**Amendments to the Drawings**

**REMARKS / ARGUMENTS**

Application No. 10/748,755  
Amdt. dated July 18, 2007  
Reply to Office Action dated April 18, 2007

Application No. 10/748,755  
Office Action dated July 18, 2007  
Reply to Office Action dated April 18, 2007  
Annotated Sheet Showing Changes

FIG. 2

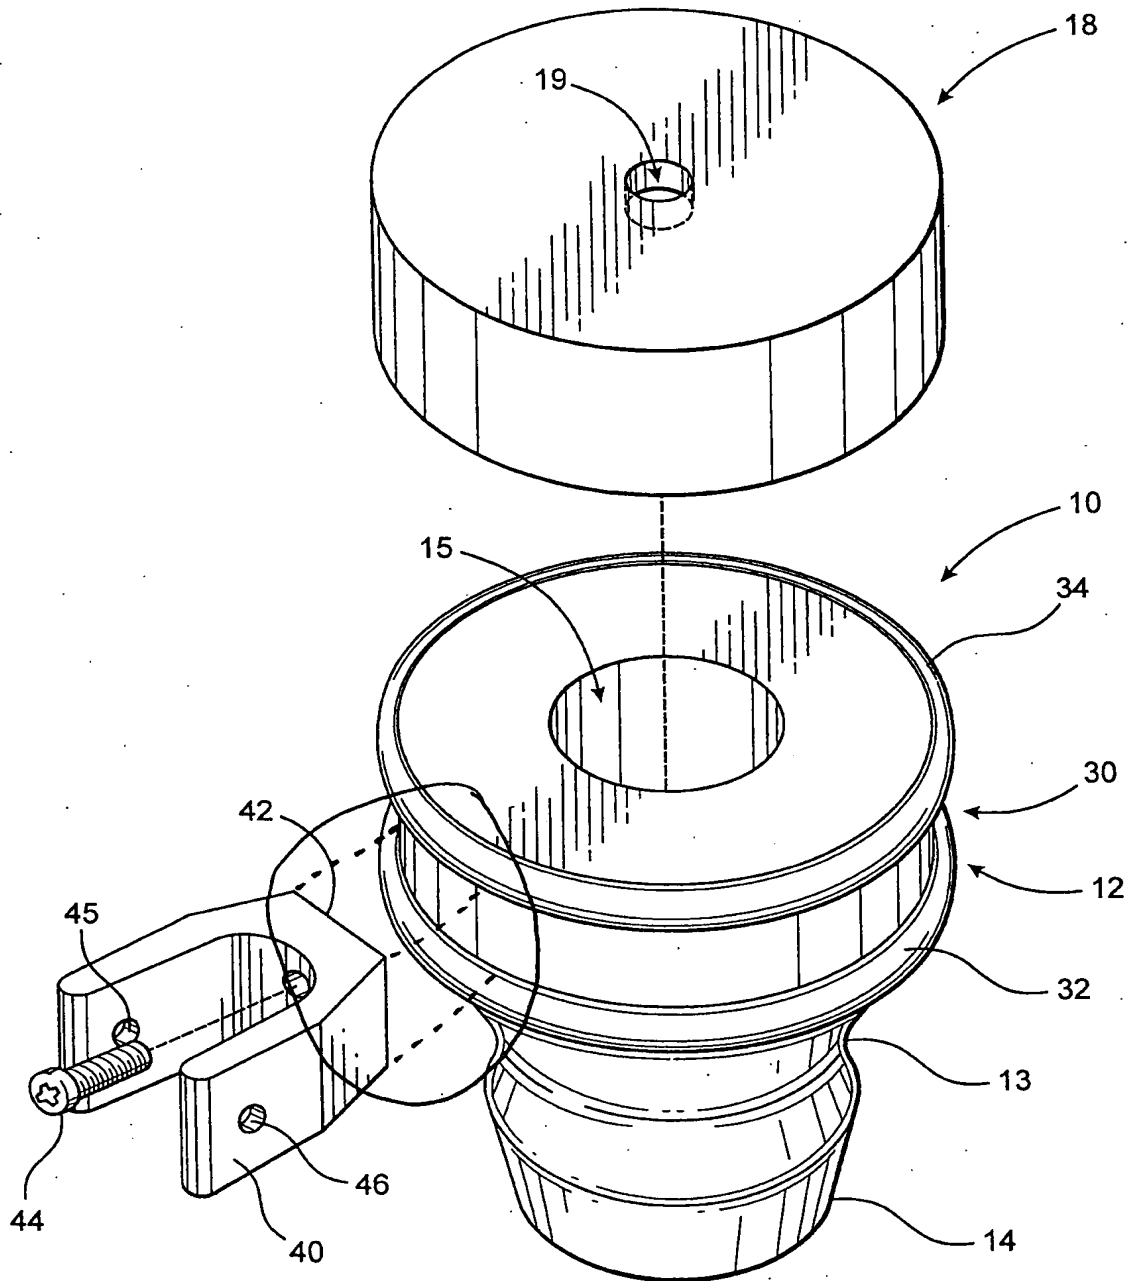
As set forth above, the PTO further objected to the drawings under 37 C.F.R. §1.84(h)(1) because of the exploded view in Fig. 2 where the separate parts within the same figure should be embraced by a bracket or a linking line in order to show the relationship or order of assembly between elements of the bracket 40 and channel 30. Accordingly, Fig. 2, as presented in the attached Replacement Sheets, has been amended herein to include a lead line to designate the relationship of the bracket 40 and the main hub member 10 and/or the channel 30 thereof.

Included with this Amendment are two (2) replacement sheets collectively comprising Figures 2 and 3B. These two (2) replacement sheets shall replace the corresponding previously submitted sheets which also collectively comprise Figures 2 and 3B. In addition, two (2) annotated sheets showing the amendments to the drawings are included for reference.

FIG. 3B

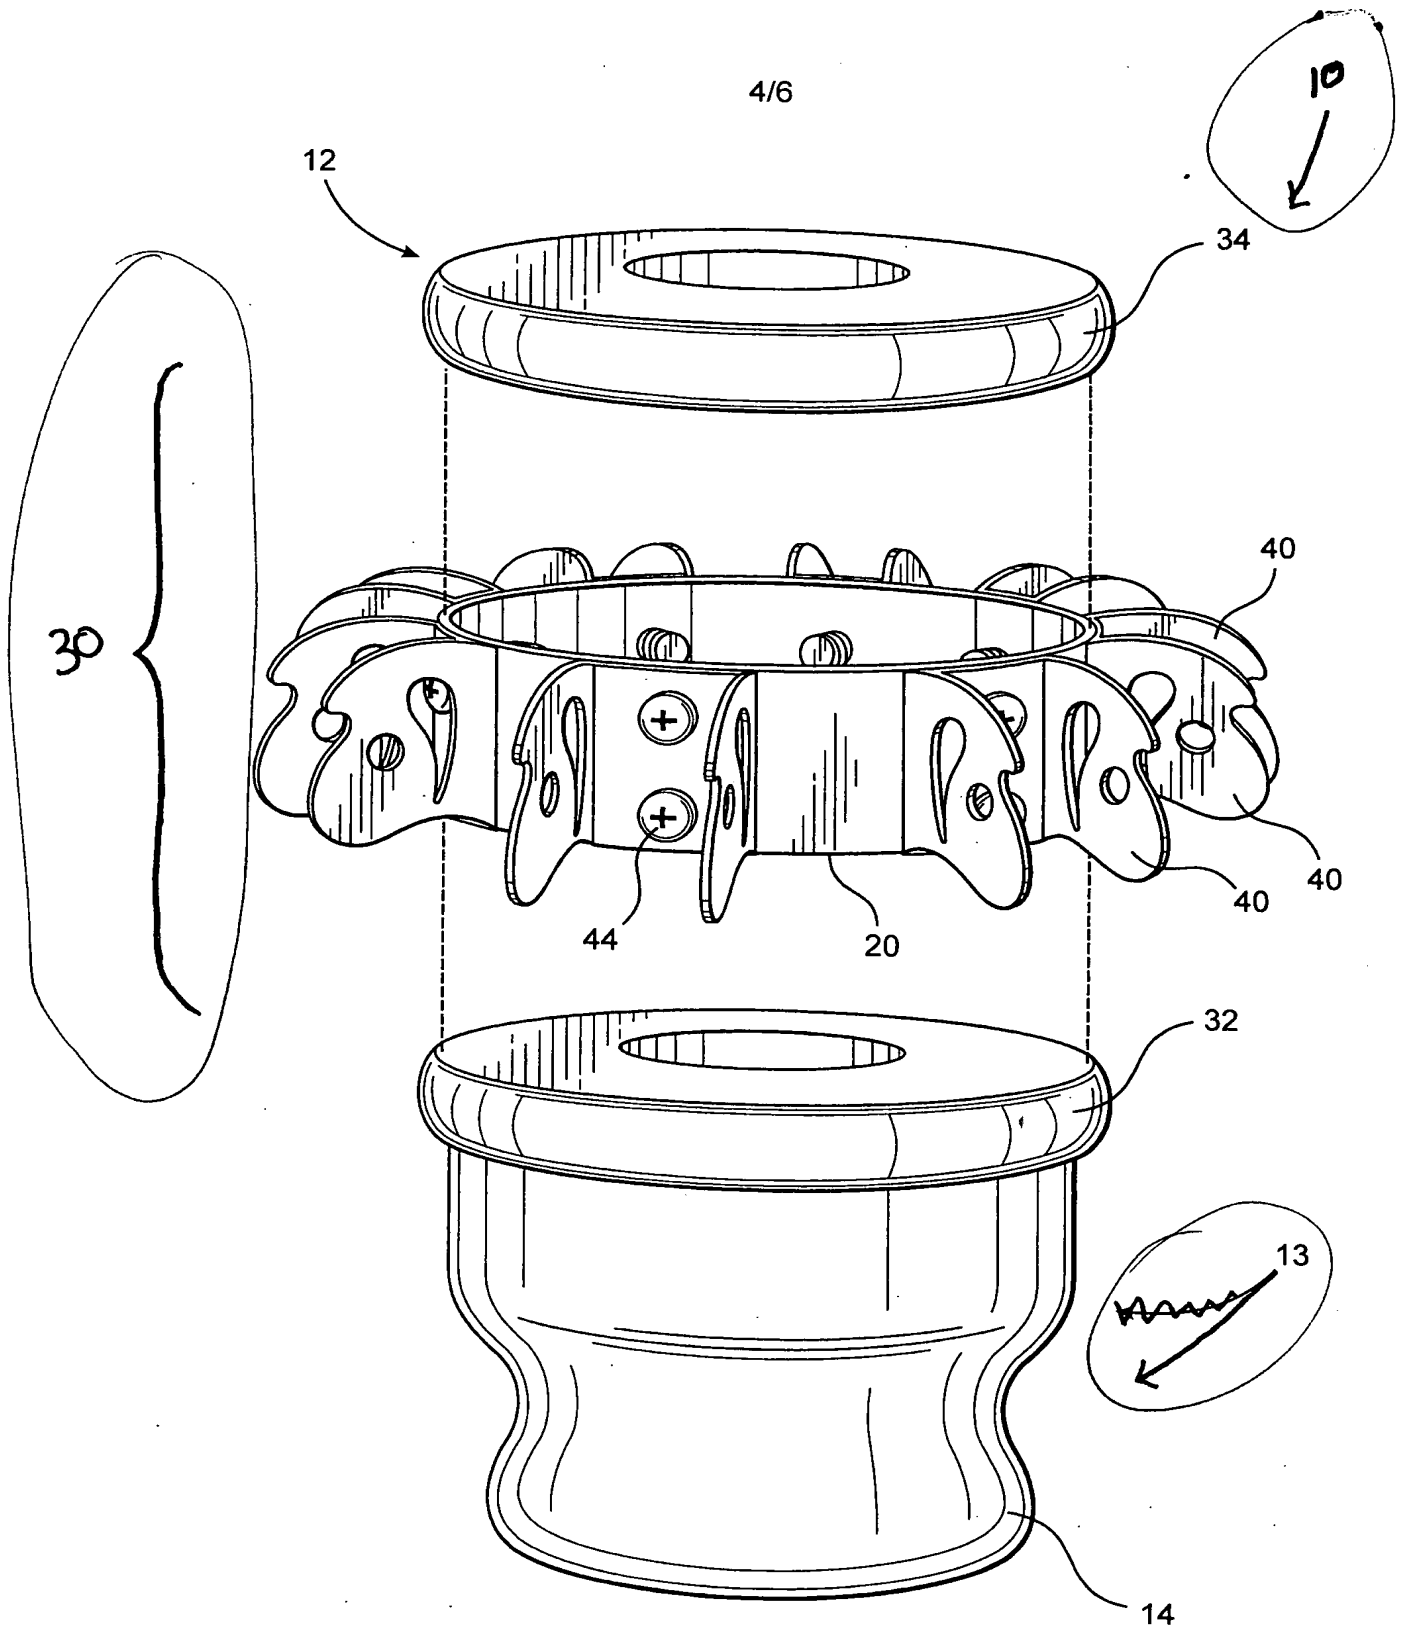
As set forth in the outstanding Office Action, the PTO objected to the drawings as failing to comply with 37 C.F.R. §1.83(a) because Figure 3B fails to show the split/separated main hub member including "both the waist 13 and a channel 30," the channel 30 being positioned between the top and bottom ledges 32, 34 as described in Applicant's specification. Accordingly, Figure 3B, as presented in the attached Replacement Sheets, has been amended herein to include reference character 30, illustrating the channel being disposed between upper portion 12 and lower portion 14. In addition, Figure 3B, as presented in the attached Replacement Sheets has been amended to further include reference character 10, illustrating the hub member as shown therein. Furthermore, as also presented in the attached Replacement Sheets, Figure 3B has also been amended herein to more accurately reference the waist 13.
